STAFF RECOMMENDATION

1411 Ordway Place

November 20, 2013

Application: Demolition; New construction- infill and outbuilding

1 SITE / ROOF PLAN
 SCALE 1/16" = 1'-0"

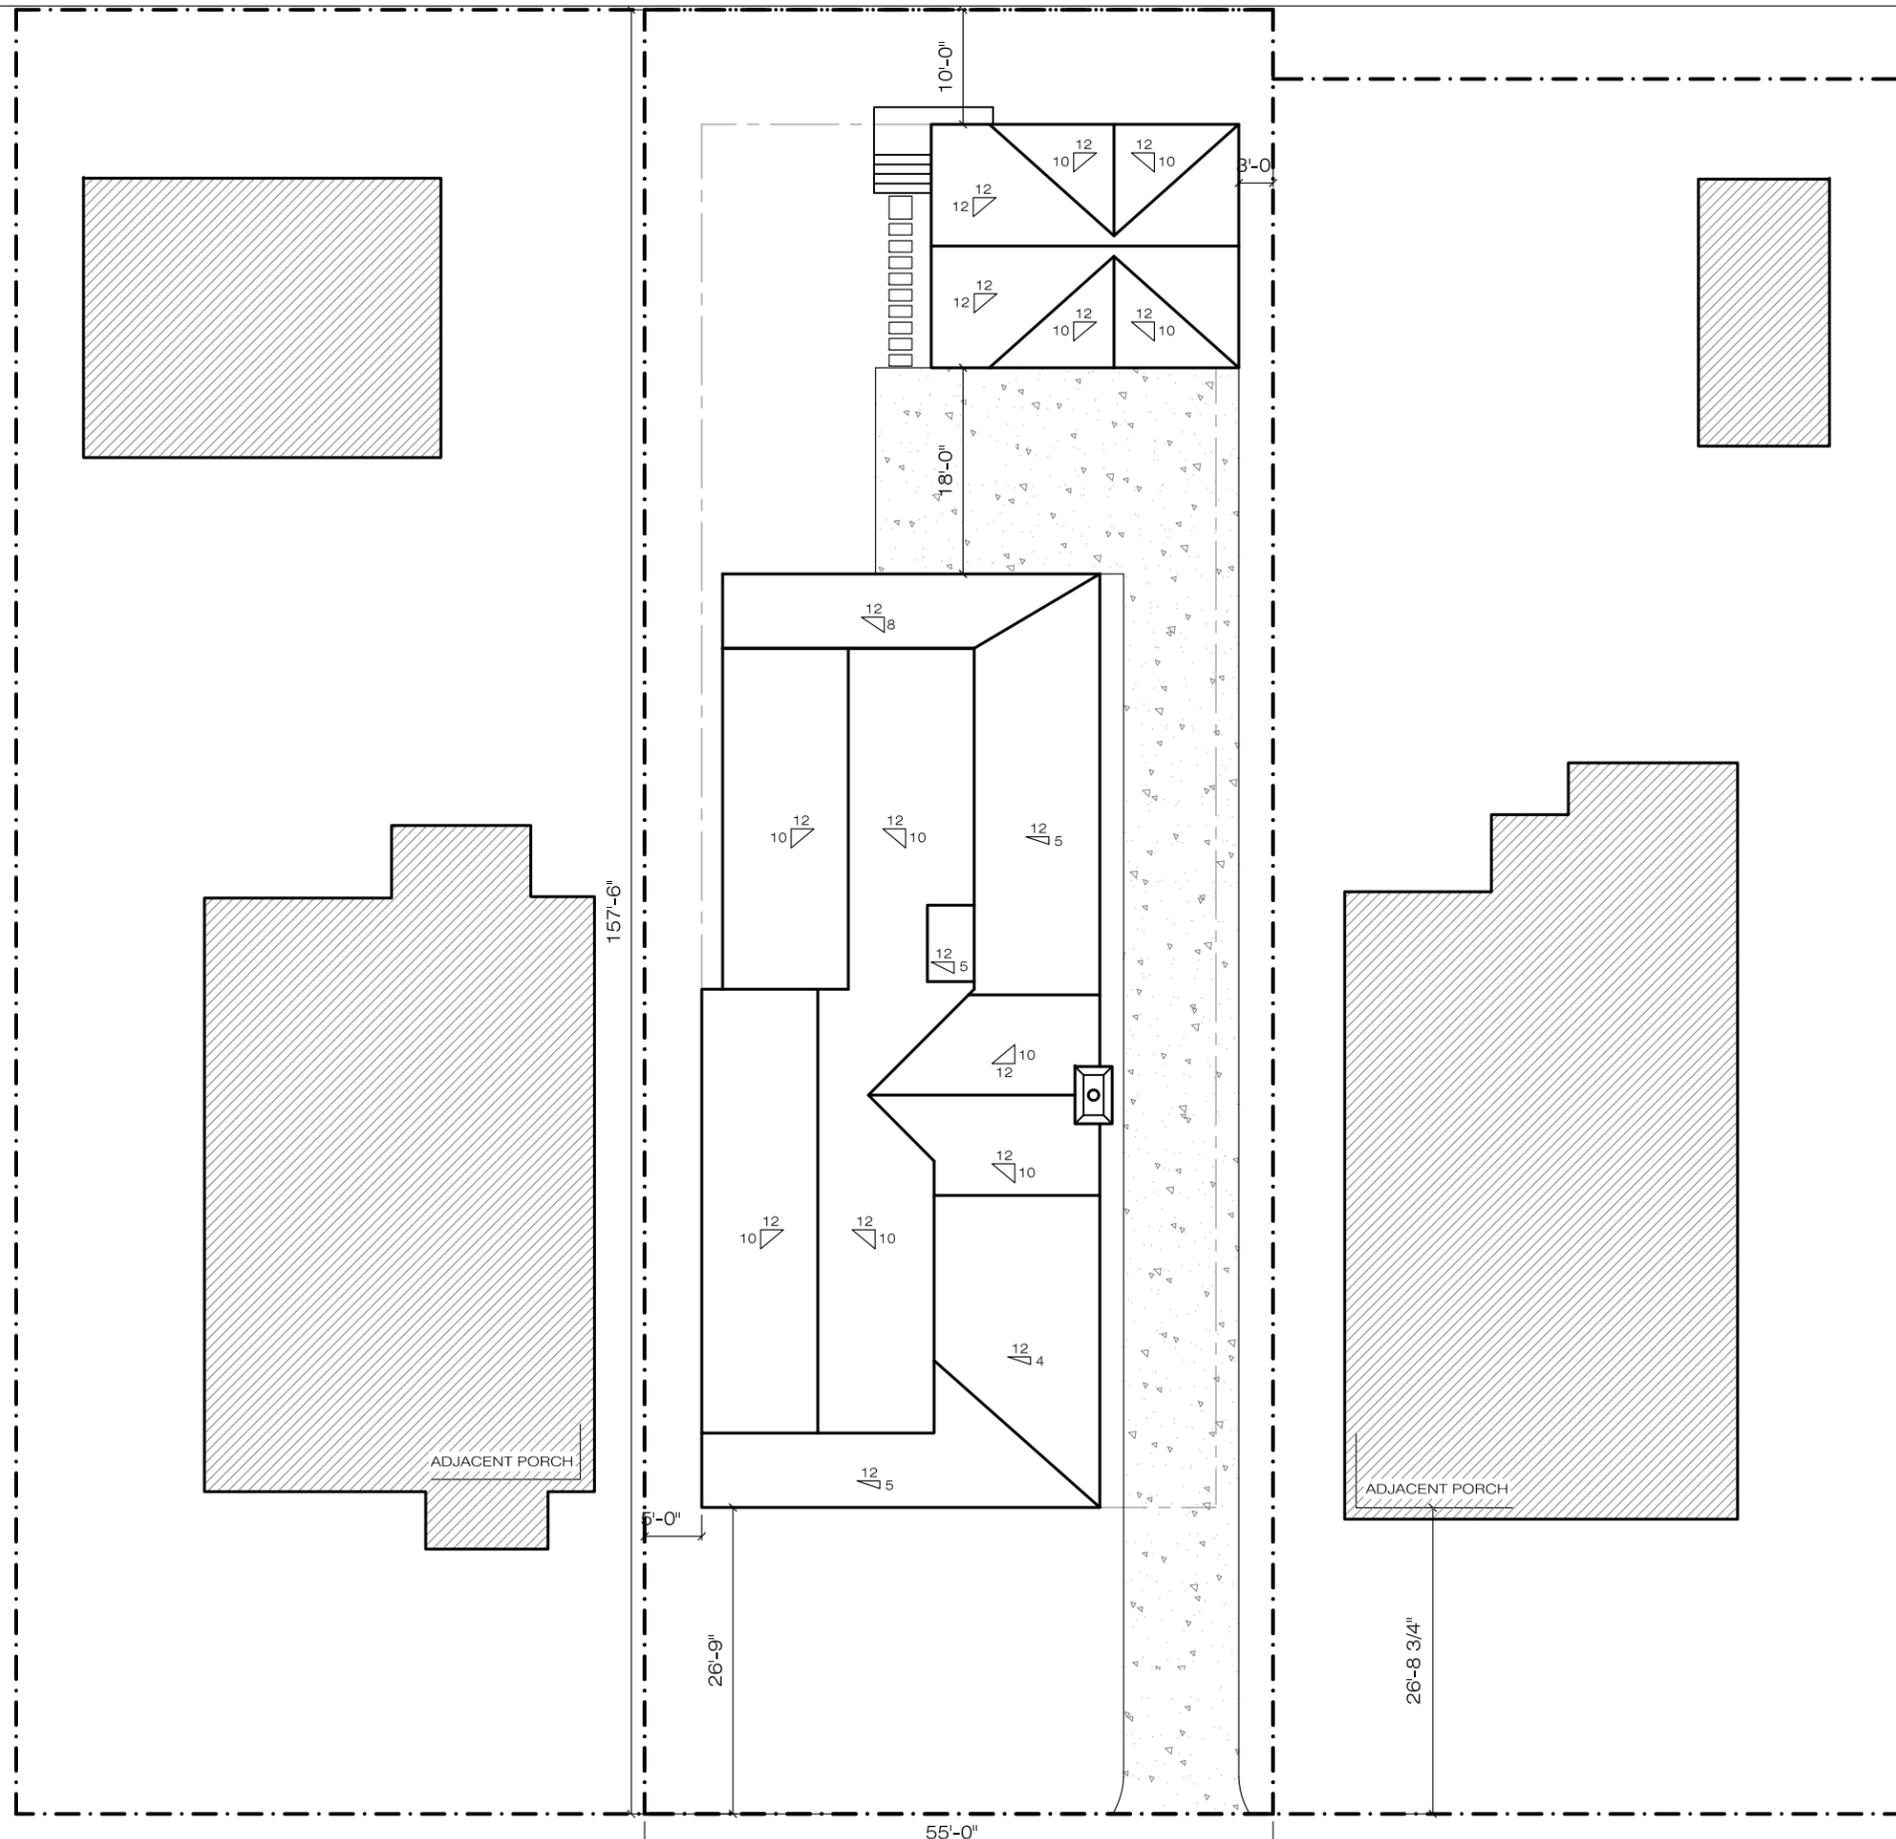
The house will be located on the lot so that the front setback is in keeping with the rhythm on the street established by historic houses, and with a five foot (5’) left side setback and a fourteen foot (14’) right side setback. This location allows the structure to retain and utilize an existing driveway. Although driveways are generally not common in the overlay, they are present at several historic houses on the 1400 and 1500 blocks of Ordway Place.

The house will be aligned with its front elevation parallel to the street, with a six foot (6') deep front porch. Staff finds that this orientation is compatible with surrounding historic houses. With a condition that a front walkway be added to connect the front porch to the public sidewalk, staff finds that the project meets design guideline II.B.6.

- Staff approve the color of the roof and the materials of the windows and doors;
- A walkway be added from the front porch to the street, and that the location of HVAC units and utilities be approved by Staff,
